SUBJECT: PUBLIC MEETING SUMMARY ON THE REACTOR OVERSIGHT
PROCESS HELD ON SEPTEMBER 19, 2007

On September 19, 2007, the staff hosted the monthly Reactor Oversight Process (ROP) Working Group public meeting. The attendance list for the meeting is contained in Enclosure 1. The agenda for the meeting is contained in Enclosure 2.

Proposed MSPI Guidance Change
Changes to CDE for Basis Document Parameters FAQ

Figure 2.2-1 High Head Safety Injection System

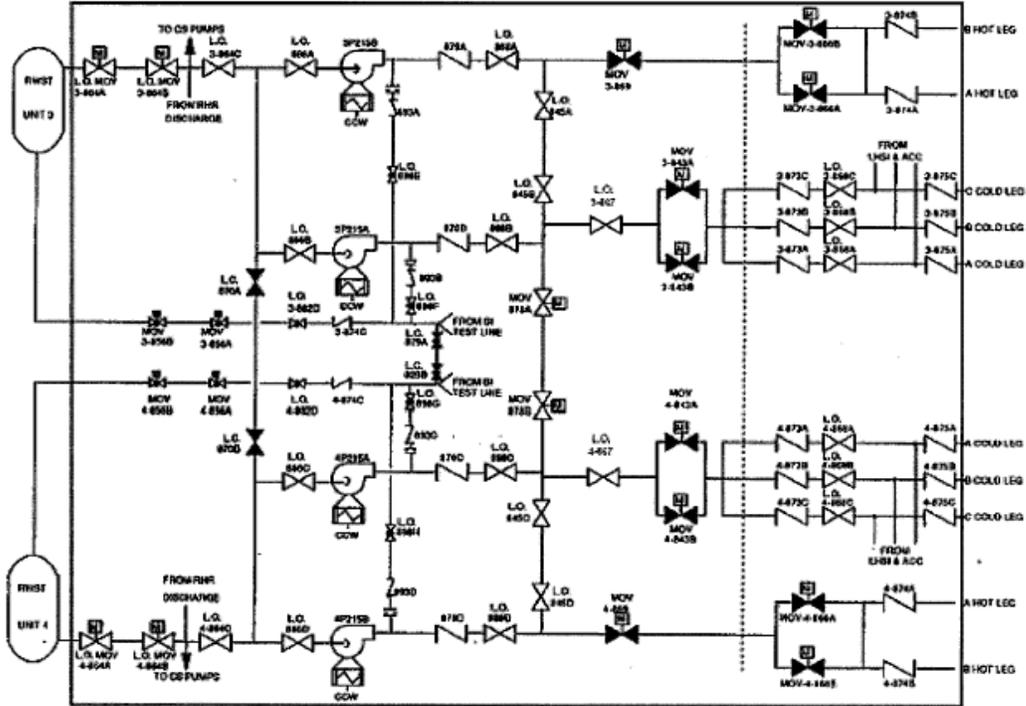
Page F-48, Section F.5, lines 45-46, and page F-49, Section F.5, lines 1-7 of the NEI 99-02, Appendix F guidance describes train determination for three-loop Westinghouse plants; however, the system described therein does not represent the HHSI system at Turkey Point. Therefore, there is no system-specific guidance for HHSI which is applicable to the HHSI system at Turkey Point.

During the week of June 4-8, 2007, an audit of the PTN MSPI programs was conducted. During his review of the PTN MSPI Basis Document proposed update, the technical expert brought in for the audit noted the uniqueness of Turkey Point's HHSI system in that both the Unit 3 and Unit 4 HHSI pumps start on an SI signal from either unit, and all of them feed the stricken unit. He also noted that the generic CCF factors for Turkey Point (NEI 99-02, Table 3) imply that there are 4 pumps being monitored for each unit. The NEI 99-02 guidance for Westinghouse 3-loop plants (pages F-48 and 49), which states that 3-loop plants have 3 pumps, one of which is an installed spare, does not apply for the Turkey Point 3-loop configuration.

For reliability monitoring, the two Unit 3 HHSI pumps are monitored for Unit 3, and the two Unit 4 HHSI pumps are monitored for Unit 4. For unavailability monitoring, the two Unit 3 HHSI pump trains and the two Unit 3 discharge valves are monitored for Unit 3, and similarly, the two Unit 4 HHSI pump trains and two Unit 4 discharge valves are monitored for Unit 4. The opposite-unit pump trains are not monitored for unavailability for either unit. The technical expert for the audit recommended that the opposite-unit HHSI pumps be added for unavailability and reliability monitoring.

At Turkey Point, each unit (Unit 3 and Unit 4) has two HHSI pumps. The Unit 3 and Unit 4 HHSI pumps start on an SI signal from either unit, and all of them feed the stricken unit. Should the Turkey Point reporting model be revised to address the four train approach?

FPL proposes to add the opposite-unit HHSI pump trains for unavailability monitoring for each unit, and the opposite-unit HHSI pumps for reliability monitoring for each unit. Although the opposite-unit HHSI pumps are cooled by the opposite-unit component cooling water (CCW) pumps, it is proposed that they not be added as they are already monitored for their associated unit, and their Birnbaum importances for the opposite-unit are several orders of magnitude less than their Birnbaum importances for their own unit.

Revise NEI 99-02, Appendix D to include the Turkey Point HHSI configuration. The current guidance for three-loop Westinghouse plants in Appendix F does not apply to Turkey Point.

Resolution: Yes. In order to ensure accurate reporting, add the opposite-unit HHSI pump trains for unavailability monitoring for each unit, and the opposite-unit HHSI pumps for reliability monitoring for each unit. Although the opposite-unit HHSI pumps are cooled by the opposite-unit component cooling water (CCW) pumps, they should not be added as they are already monitored for their associated unit, and their Birnbaum importances for the opposite-unit are several orders of magnitude less than their Birnbaum importances for their own unit.
